RUSKIN *air handling specialties*

May 10, 1983

Director, Office of Inspection and Enforcement
U. S. Nuclear Regulatory Commission
Washington, D. C. 10555

Subject: Backdraft Damper Counterweights

CBS 7

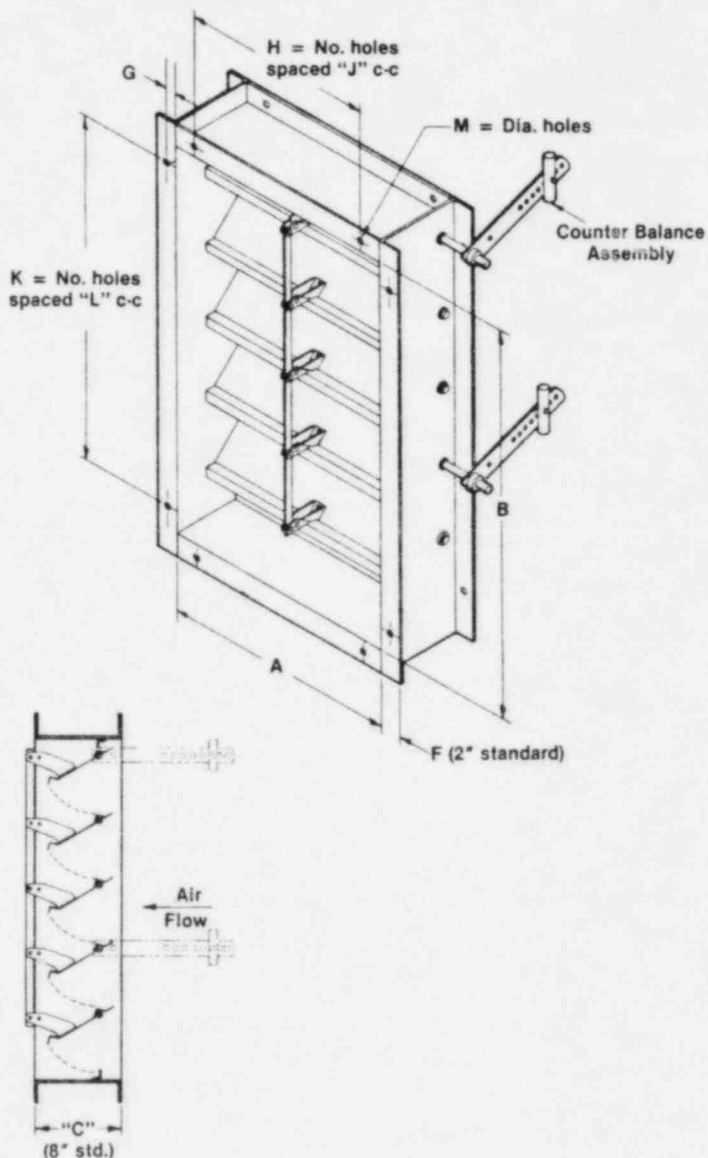
On April 29, 1983, it was determined that Seismic Report Number 1018 for Backdraft Dampers (Model CBS-7 and CBS-8) did not address the counterbalance assemblies for seismic characteristics required by Ebasco Services, Inc. for their Shearon Harris Nuclear jobsite. Corrective Action for this jobsite has been identified, Ebasco notified, and arrangements are being made to install an additional counterbalance arm.

On May 10, 1983, information was available which reasonably indicated a deficiency. The deficiency discovered indicated that the counterbalance arm assemblies were not addressed in Ruskin Manufacturing Company's Seismic Reports. It was further discovered that, because the counterbalance assembly has a natural frequency less than 33 Hz., certain weight-acceleration combinations result in unacceptable stresses in the counterbalance arm.

It has recently come to our attention that external counterweight assemblies on CBS7 and CBS8 type Backdraft Dampers may, in some instances, not meet seismic qualification criteria.

The counterweight assembly will, in most cases, have a natural frequency less than 33 Hz for its weaker axis (perpendicular to the damper axle). Where peak acceleration levels result in unacceptable stresses in the arm, a second arm will be required to stiffen the assembly.

In the event that testing should prove additional work is required, Ruskin Manufacturing Company will install an additional counterbalance arm on every damper supplied to Nuclear Power Plant sites as required.

We will be contacting you with further information and making arrangements to have an additional arm installed where necessary as soon as possible.
